Preserve Block 299
Traffic Impact Study

Proposed Residential Development Town of Oakville

Draft Site Plan Comments Report

Date:	October 13, 2021		
To: cc:	Bailey Russell, Mattamy Catherine McEwan, Korsiak Urban Planning	bailey.russell@mattamycorp.com catherine@korsiak.com	
From:	Kelly Livingstone, Planner, Plann	ing Services	
Contact Info: T: 905-845-6601 ext. 3045		5	
	F: 905-338-4414		
	E: kelly.livingstone@oakville.ca		
Re:	Site Plan Circulation Comments	(3rd submission)	
Application:	Pendent Developments (Carding Mill Trail)		
Description:	Five storey mixed use building and five storey apartment building		
Address:	3279 Carding Mill Trail		
Site Plan File #:	e #: SP.1318.005/01

Figure 9 2027 Future Total Traffic Volumes

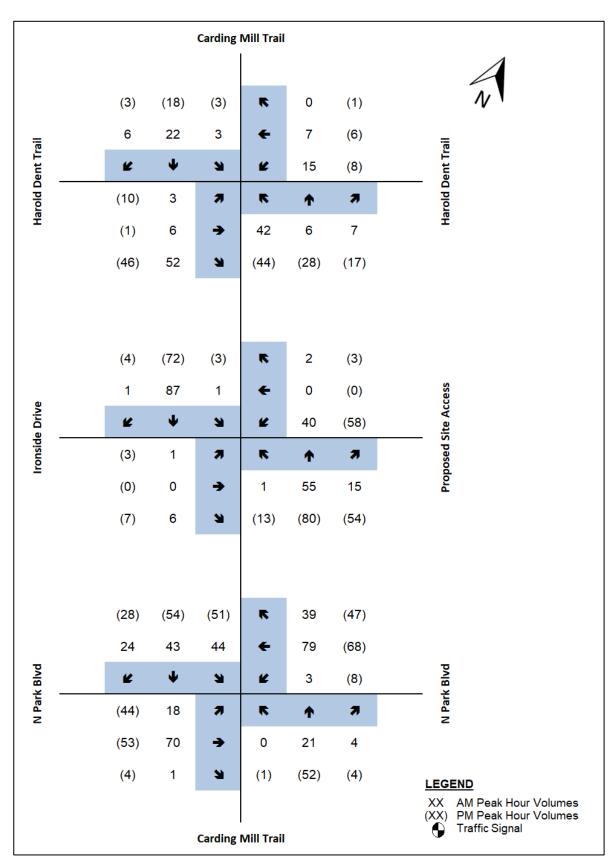
- 1. [Circ. 2 addressed] Ref TIS report, figure 9-Total Traffic Volumes year should be updated.
- 2. [Circ. 2 addressed] Staff appreciate using (5%) higher growth rate of study area considering Region's land allocation plan.
- 3. [Circ. 1 Addressed] TIS for the proposed development is not submitted, the traffic consultant should collect the TMC's of the project study area as per the TOR and submit the report for review and comments by Transportation Strategy.

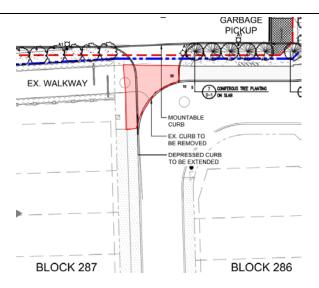
[Circ 2] Comment not satisfied. Grading plan is showing a 5.5% cross slope on the pedestrian walkway where it crosses the vehicle entrance. The maximum cross slope should be 4%, 2% preferred. The concrete walk should extend across the driveway to meet the pond trail to better define it from the driveway. If there is a concrete walkway in front of Block 287, the concrete walk should continuously connect to it. Clarify treatment in front of Block 287.

[Circ 1] Clarify / provide a barrier free pedestrian connection through the vehicular entrance at the rear of the property. Pedestrian walkway should be maintained at a constant elevation (not slope/ramp down to driveway, as per OPSD 350.010).

13. [Circ 3] Comment addressed.
